Access Compliance Report

Public Rights-of-Way

(Curb Ramps)

Intersection ID: 12080	Main Street: E_15TH_ST	Cross Street: SEIGLE_AV	Location:	N
ADA ID: CC59016E0CF4	Ramp Type: Perp	Initial Pass/Fail: Fail	Overall Compliance: No	Severity Score: 12.5
Codes/Mitigation Info/Possible Solution		Field Measurements/Component Compliance

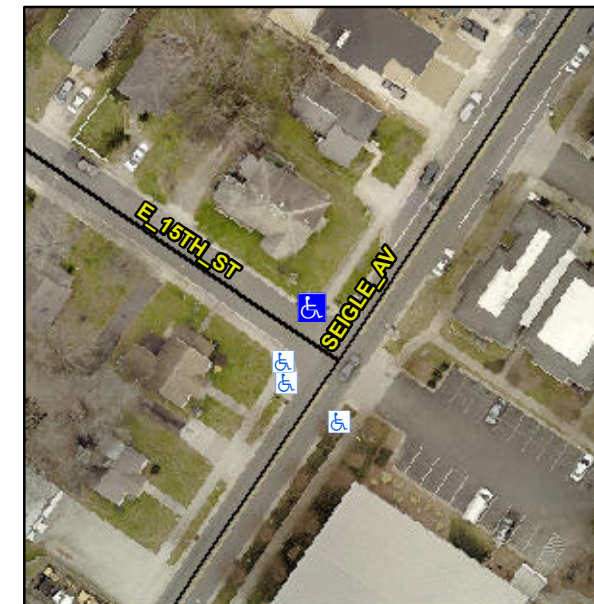
Not Found, R304.2.2

Compliance	Description	Data	Compliance	Description	Data
N/A	Ramp Length (in)	70.5	No	Ramp Slope (%)	9.0
Yes	Ramp Width (in)	94.0	Yes	Ramp XSlope (%)	1.3
N/A	Flare Type LT	N/A	N/A	Flare Type RT	N/A
N/A	Flare Slope LT (%)	N/A	N/A	Flare Slope RT (%)	N/A
N/A	Flare Traversable LT?	N/A	N/A	Flare Traversable RT?	N/A
N/A	Landing Length (in)	N/A	N/A	DWS Provided?	N/A
N/A	Landing Width (in)	N/A	N/A	DWS Contrast?	N/A
N/A	Landing Slope (%)	N/A	N/A	DWS Length (in)	N/A
N/A	Landing X Slope (%)	N/A	N/A	DWS Full Width?	N/A
N/A	Landing Curb? (Y/N)	N/A	N/A	DWS Offset (in)	N/A
N/A	Shared Landing?	N/A			
N/A	Gutter Ponding?	N/A	N/A	Gutter Slope (%)	N/A
N/A	Gutter Lip Ht (in)	N/A	N/A	Gutter X Slope (%)	N/A
N/A	Painted X Walk1?	No	N/A	Painted X Walk2?	N/A
	X Walk 1 Direction	To SW		X Walk 2 Direction	N/A
N/A	X Walk 1 Width (in)	N/A	N/A	X Walk 2 Width (in)	N/A
	X Walk 1 Slope (%)	0.3		X Walk 2 Slope (%)	N/A
	X Walk 1 X Slope (%)	0.0		X Walk 2 X Slope (%)	N/A

Remove & Replace Entire Ramp.
